**Consideration of Comments on 2<sup>nd</sup> Posting of Determine Facility Ratings, System Operating Limits and Transfer Capabilities Standard**

The Balance Resources and Demand Standard Drafting Team (BRD SDT) thanks all those who submitted comments with the second posting of the standard. The standard was posted from June 2–July 2, 2004, and the drafting team received comments from 98 individuals in 61 different companies. These commenters collectively represent all NERC Regions and 8 of the 9 Industry Segments.

*Four basic mixups of technical concepts in the "Frequency Profile" section of the Introduction.*

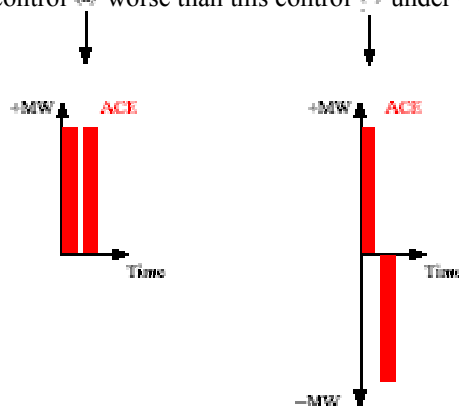
**Mix-up #1.** *Mixing up ACE with  $ACE \times \Delta F$ ; mixing up counterclockwise "rotation" of a profile curve with upward "shift" of a profile curve.* The Policy 1 control performance objective is to control, not ACE to be near zero, but  $ACE \times \Delta F$  to be less than  $-10 \times \text{Bias} \times \epsilon^2$ , where  $\epsilon$  is some frequency error limit. The bogus claim that the objective is control of ACE alone (to be near zero), sets the stage for the next mix-up. Also, mixing up ACE with  $ACE \times \Delta F$  allows the writer

- (a) to mix up the job of CPS 2 (which is an ACE alone performance measure to limit not by how much but by how often ACE could exceed  $L_{10}$ , which is not near zero) with the job of CPS1 (which is an  $ACE \times \Delta F$  performance measure),
- (b) to claim that CPS 2 should have had some effect on  $ACE \times \Delta F$  when it couldn't have and, then,
- (c) to use this failure as an excuse to replace CPS-2 with a second  $ACE \times \Delta F$  measure known as CPM-60. Moreover, the mix-up causes the CPS-2 failure to be mischaracterized or misunderstood as a *deterioration* in the shape of the frequency profile "curve", in the form of a *flattening* or *rotation* of the curve, when it was instead a mere *shifting* upward of the entire unchanged frequency profile "curve" that a single appropriately set CPM-1 limit can stop!

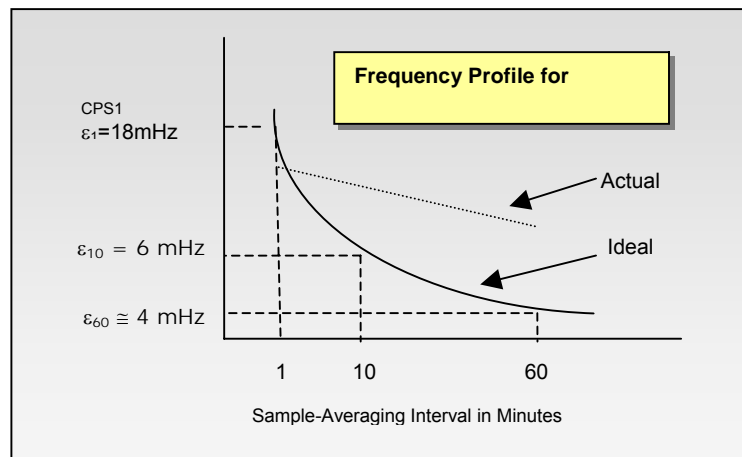
2 comments on California ISO's proposed alternative to CPM-60 in Appendix 1 of the Responses to Comments. CA ISO doesn't question CPM-1, but rather proffers an "improvement" to the proposed CPM-60 standard. CA ISO does not provide justification for the two key points of (claimed improvement in) its proposal, by not answering the following two questions:

1. Why/how is a linear, absolute-value (first-moment) measure of variability (MAE) superior to the quadratic (second-moment) measure of variability (RMS) that we currently use and that has permeated the mathematics of statistical science? Why and how is it superior despite the contrary results of theoretical statistics' founders best efforts? In particular, CA ISO needs to offer a revision/replacement for the very powerful "moment generating function" that is the very foundation of modern statistics and physics, and define "linear" moments.  $\eta$  is just an ad hoc number to somehow bridge the gap between a convenient "mean average error" (MAE) measure and the "root of the mean of squared errors" (RMS) gateway to the body of statistical science.

2. Why is covarying individual performance with system performance, as we currently do, a bad way to assess performance, not a good way? Answering that would address the deep philosophical issue of performance "relativity" and why or why not to make assessment of individual performance relative to collective performance. While probability and relativity have been the hallmarks of modern physics, need we seek to make individual (say, BA) performance more "absolute" and less relative to "collective" (say system, frequency) performance? MAE allows for no covariance, no correlation. This excludes the whole area of diversity and benefit from interconnected operations, leaving MAE to provide control that is either too tight or too loose relative to the state of the system. Doing so in a social-technical system like the interconnected electric grid runs the risk of rejecting the progress of modern (relativistic and probabilistic) physics over classical (absolute) Newtonian physics in dealing with physical systems whose components strongly interact even more than in your run-of-the-mill social system.

### Single point control:

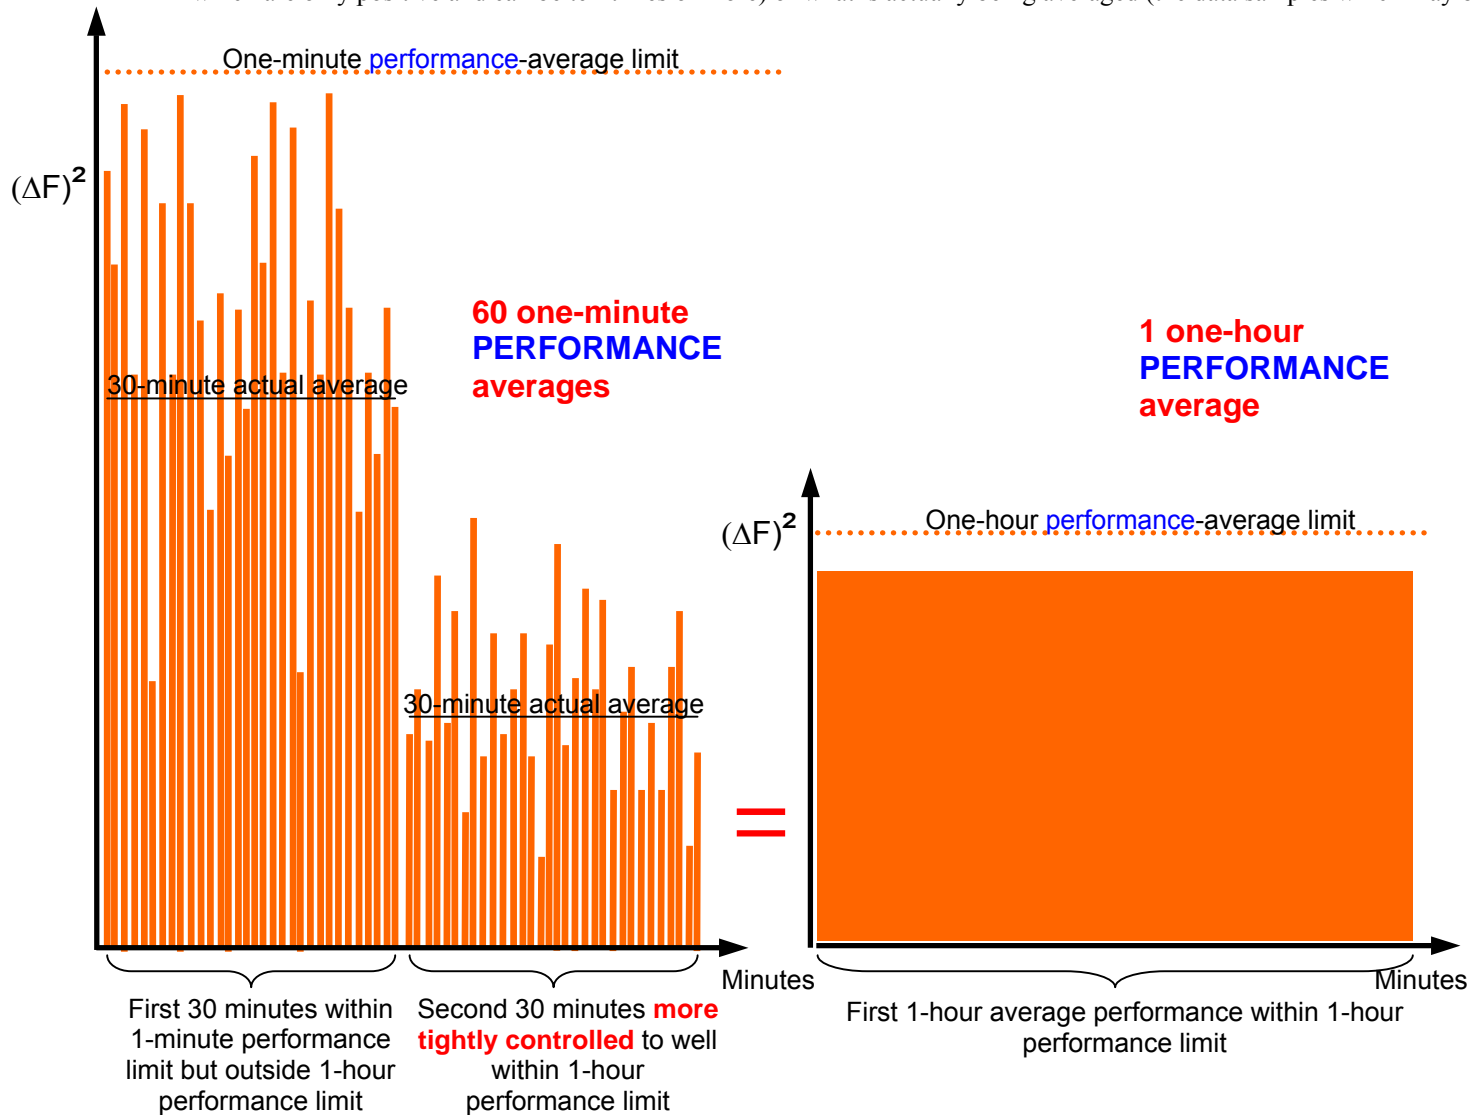
"For those who adopt the experienced frequency as the target, **one point** of the characteristic [profile], anywhere from one minute to 20 minutes, **is sufficient** for enforcement. If this point is chosen at **one minute**, then  $\epsilon = 8.5, 6.5,$  and 12 mHz, for the Eastern, WSCC, and ERCOT interconnections, respectively. In this case **no other point** would need to be enforced because with these  $\epsilon$  values it is **very unlikely for the tail of the characteristic [profile] to degrade!**", Jaleeli, N., and VanSlyck, L., *Control Performance Standards and Procedures for Interconnected Operation*, EPRI report RP 3555-10, Palo Alto (CA), August 1996, p. 3-18.

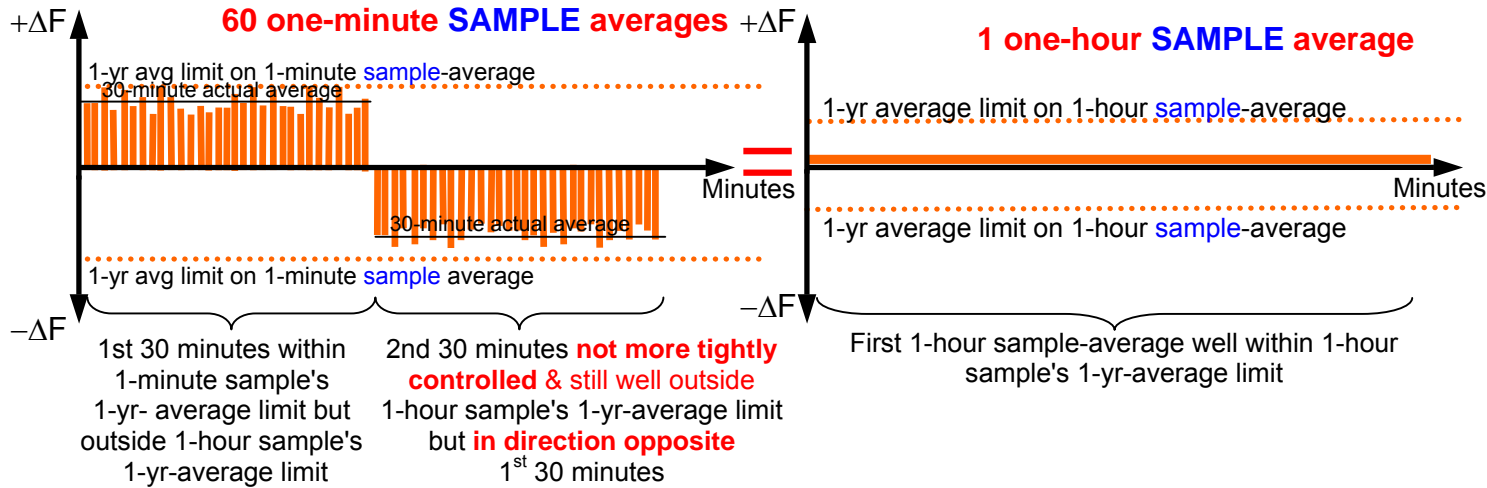
1. **Wrong** interpretation of CPM-60 as a 60-minute "performance average" subject to a "tighter-performance" limit than CPM-1 misinterpreted as a 1-minute "performance average" [Note: deviations being "averaged" within one hour are grossly exaggerated in the graph as the "square" (which is the "performances", which are only positive and can be ten-times or more) of what is actually being averaged (the data samples which may be negative)]:

2. **Correct** interpretation of CPM-60 as the annual performance-average of a 60-minute "sample average" subject to a "variability" limit tighter than the limit on CPM-1 which is the annual performance-average of a 1-minute "sample average" [Note: deviations being averaged within one hour are the "data samples", which are much smaller (one-tenth or less) than (or even negative) what the "performances" would be were they calculated every minute!]:
